UNITED STATES PATENT AND TRADEMARK OFFICE

APPLICATION NO.	FILING DATE	FIRST NAMED INVENTOR	ATTORNEY DOCKET NO.	CONFIRMATION NO.
10/055,101	01/22/2002	Steven G. Goebel	8540G-000096	9631

Office Action Summary

DETAILED ACTION

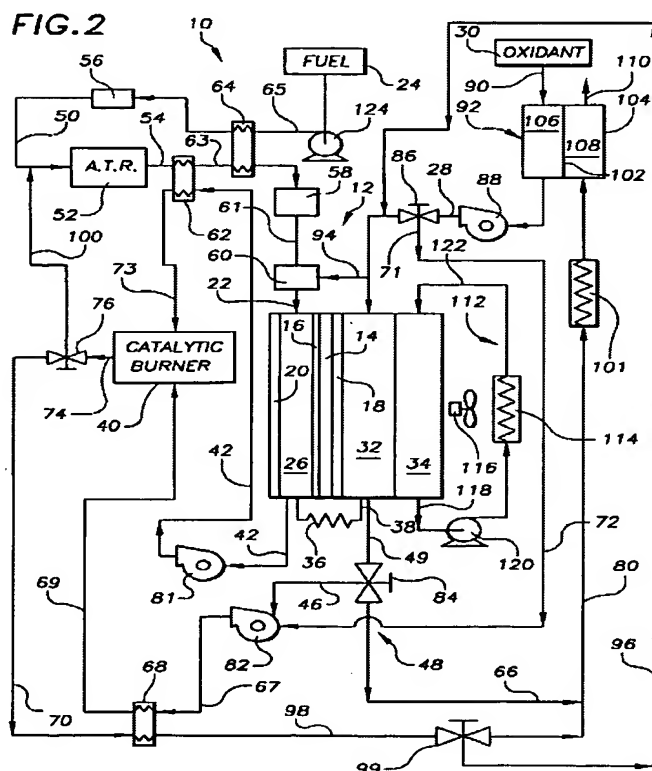
Van Dine et al's **Figure 2** below illustrates a schematic representation of a fuel cell power plant showing split passages of the system:

In particular, **Figure 2** depicts a reformer 52 comprising an inlet and outlet; a burner 40 having an inlet and an outlet. The burner inlet is in fluid communication with the fuel processor outlet via extension lines 63 and 61, the anode exhaust passage 42 and extension line 73.

A recirculation loop including a valve 76 for selectively providing fluid communication between the fuel processor inlet and at least the combustor outlet is also illustrated.

A bypass passage providing fluid communication between the recirculation loop and the combustor inlet is illustrated by the passage including extensions 70 and 98, the diversion line 96, the exhaust passage 49, and the extension 69.

Any of valve 99, valve 86 or valve 84 selectively provides fluid communication between the recirculation loop and the combustor inlet.

Van Dine et al teach that all extension passages and their respective valve are operable to set a recirculation ratio (COL 14, lines 34 to Col 15, line 15).

Any of valve 74, valve 99, valve 86 or valve 84 is able to control fluid communication in the recirculation loop.

Fluid compression means 81 and 82 are in fluid communication with the recirculation loop.

FIG.1

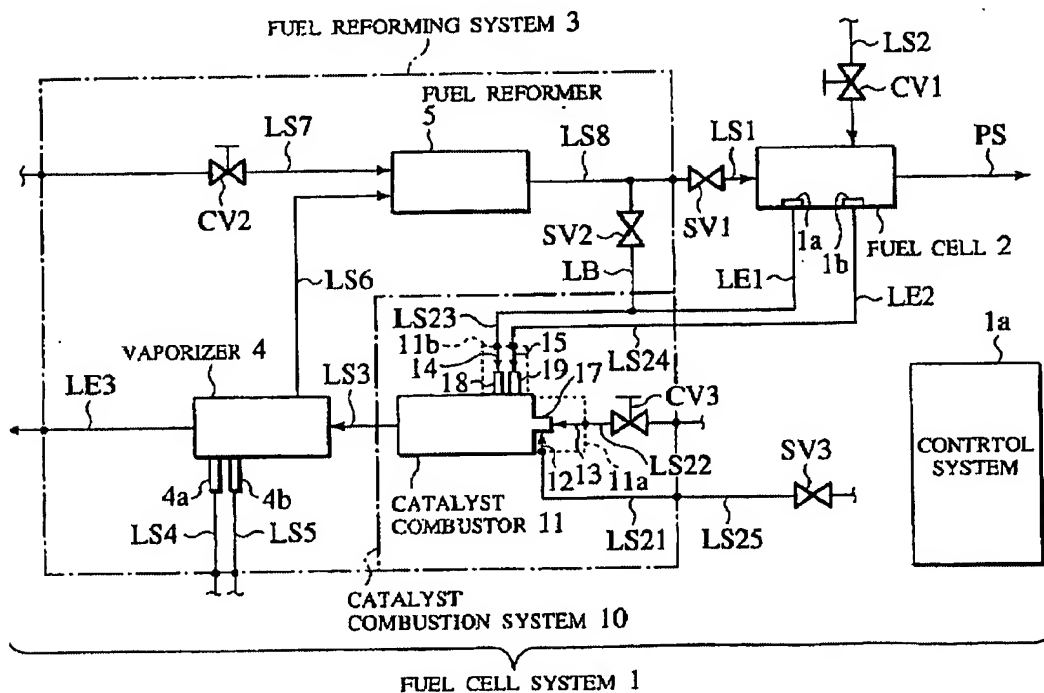
Kobayashi in **Figure 1** below depicts a block diagram of a fuel cell system including a reforming system 5 having a combustion system 11 wherein the combustor inlet is in fluid communication with the reformer outlet via the reformed fuel supply line LS1 and the reformed fuel bypass line LB that has shutoff valves SV1 and SV2 and ; the combustor supply line LS3 is also in fluid communication with the reformer inlet. Valves SV1 and SV2 selectively provides fluid communication between the recirculation loop and the combustor inlet, and they are both operable together for setting the required fluid flow therein (SECTIONS 0023-0032).

FIG. 1

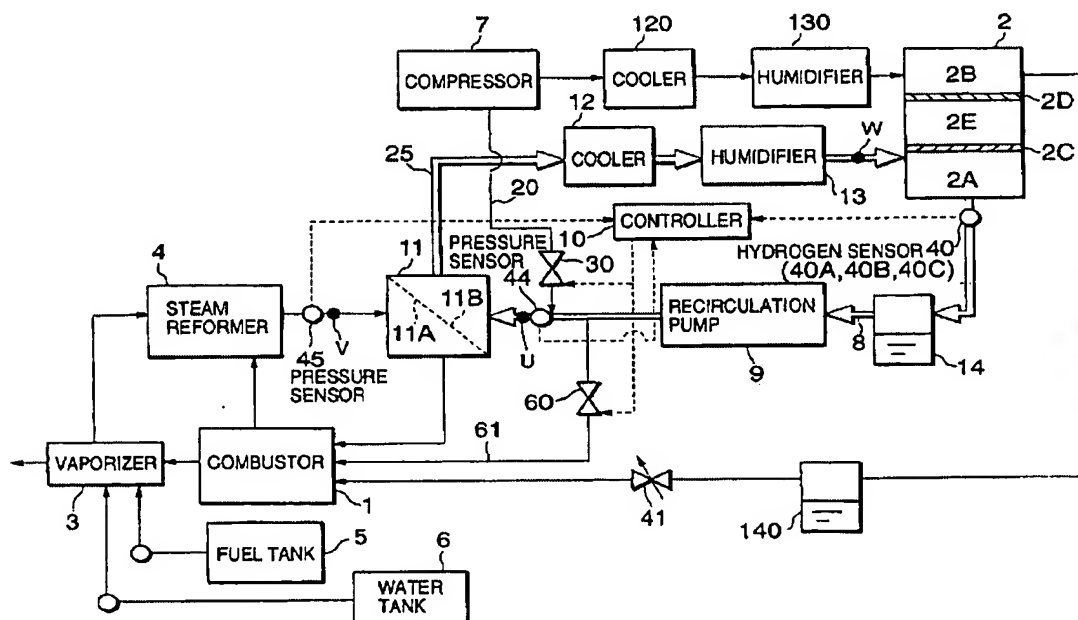
Ito et al teach a reformer 4 and a combustor 1 wherein both the reformer and the combustor include inlet and outlet. It is disclosed that the combustor 1 generates heat by reacting gas containing hydrogen supplied from the anode effluent recirculation passage 8 through a discharge valve 60 and reformat gas generated by the steam reformer 4 with oxygen contained in the cathode effluent supplied through the pressure control valve 41 (SECTION 0028). As shown in **Figure 1** below, the recirculation loop includes a valve selectively providing fluid communication between the reformer inlet and the fuel processor outlet and the combustor outlet. The fuel processing system further includes a recirculation pump 9 in fluid communication therewith.

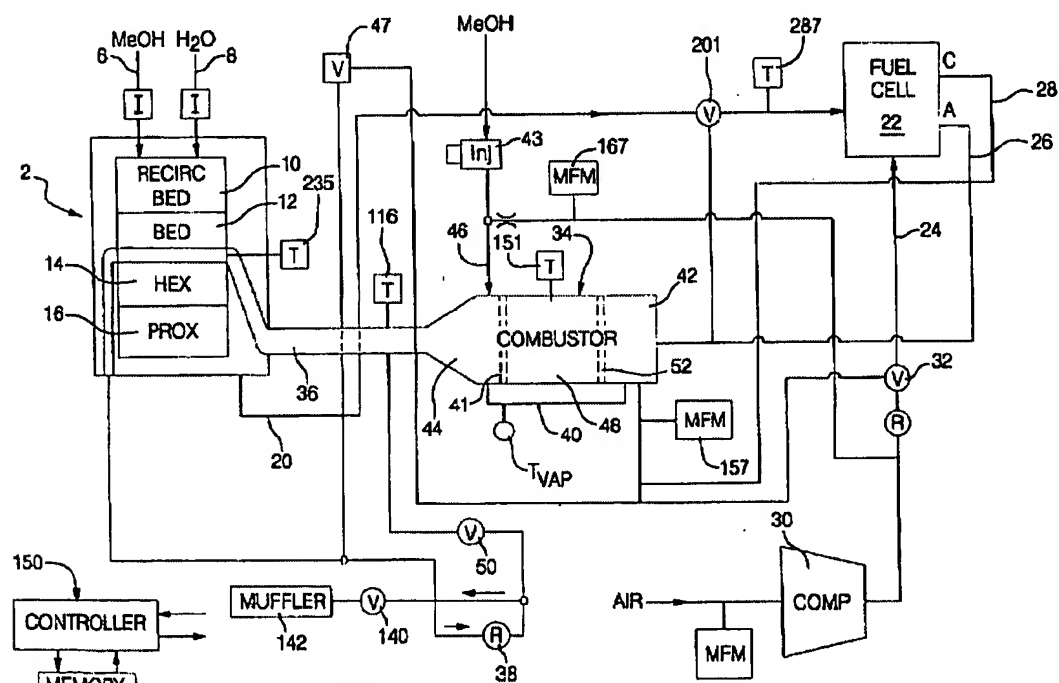
Hart-Predmore et al disclose a fuel processing apparatus comprising a fuel processor 2 and combustor 34, both of them including respective inlets and outlets; wherein the entire output of the fuel processor 2 is recirculated to the combustor 34 as fuel through a fuel bypass valve 201 which supplies the fuel processor output gas stream to a second inlet on the combustor 34 (COL 11, lines 45-65).

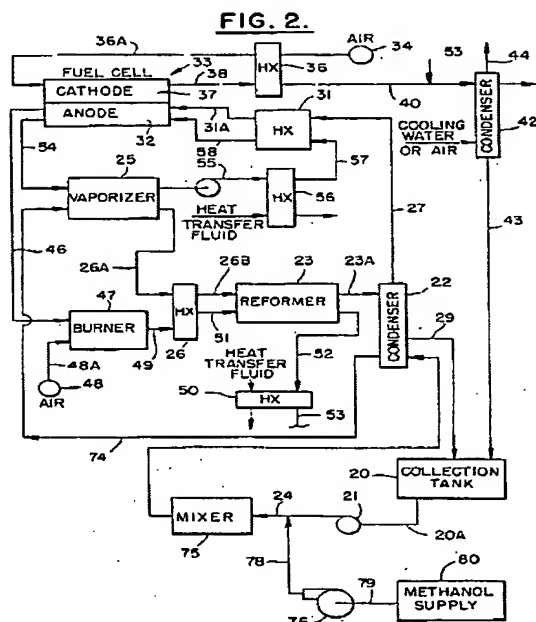
Beshty et al illustrate in **Figure 2** below gas stream exiting reformer 23 passing through line 23A and into condenser 22 where the gas stream is cooled to a lower temperature within a preferred working temperature to condense much of its water content by heat exchange with the as yet unreformed water/methanol feedstock being circulated therethrough (COL 6, lines 20-28).

In view of the above, it would have been obvious to one skilled in the art at the time the invention was to use the condenser in fluid communication with the fuel processor outlet of Beshty et al in any of the fuel processor of either Van Dine et al'366 or Kobayashi'141 or Ilo et al'024 or Hart-Predmore et al'561 because Beshty et al teach that the gas stream exiting reformer is feed into the condenser where the gas stream is cooled to a lower temperature within a preferred working temperature to condense much of its water content by heat exchange with the as yet unreformed water/methanol feedstock being circulated therethrough. Thus, the condenser is employed to condense water of gas stream.
